Operational Alert: 162
Date: September 13, 2006
Subject: Aileron Link Cables and Turnbuckle
Compliance: Mandatory
Models Affected: All S-7LS and S-7S models

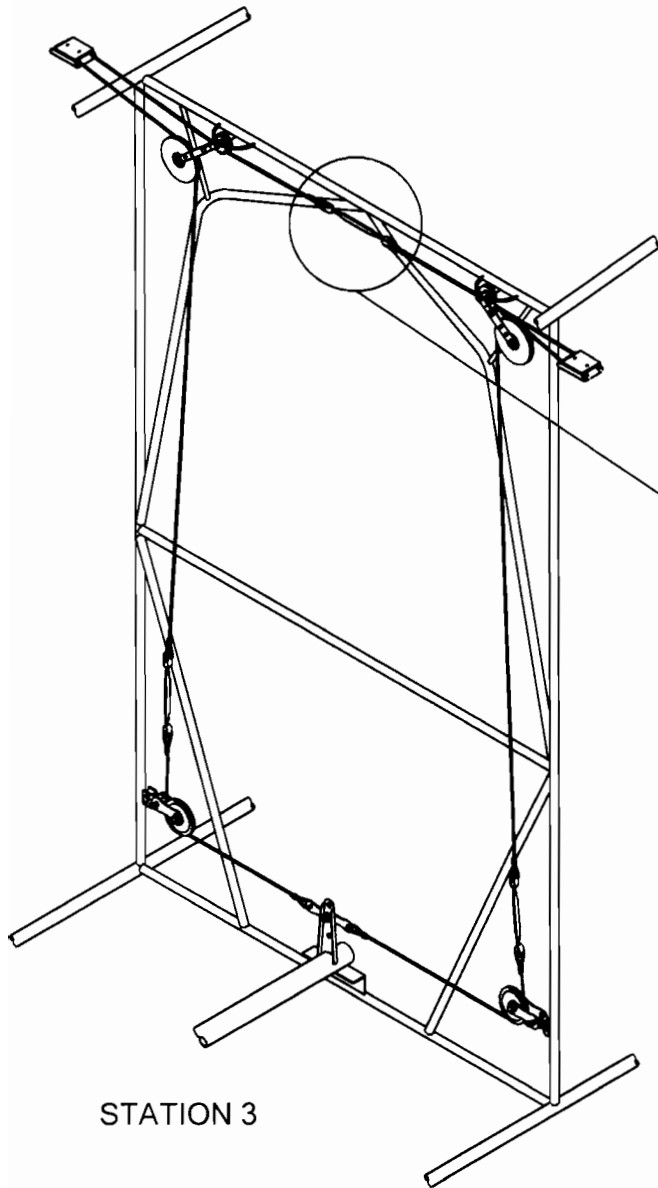
Prior to the next flight, inspect upper Turnbuckle at Station 3 for thread engagement (Reference attached drawing).

A minimum of 6 threads should be engaged on each end of the Turnbuckle.

If this cannot be assured, change Turnbuckle to part # RL-335-BT. Turnbuckle RL-335-BT is slightly longer and available from RANS Parts Department.

STATION 3

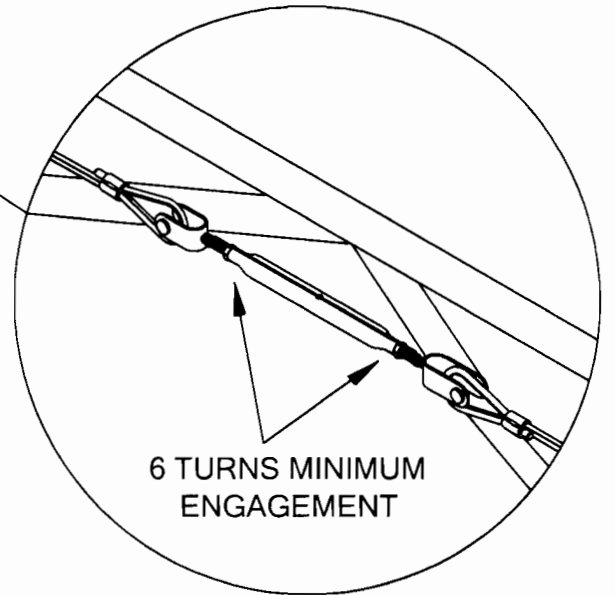
During assembly of an aircraft at the factory, we noted that only 4 threads could be engaged on the upper Turnbuckle at Station 3 (connecting Aileron Link Cables). Investigation showed that some Aileron Link Cables have been made too short.

TURNBUCKLE IS RL-335-AT
CHANGE TO RL-335-BT
IF REQUIRED.

6 TURNS MINIMUM
ENGAGEMENT
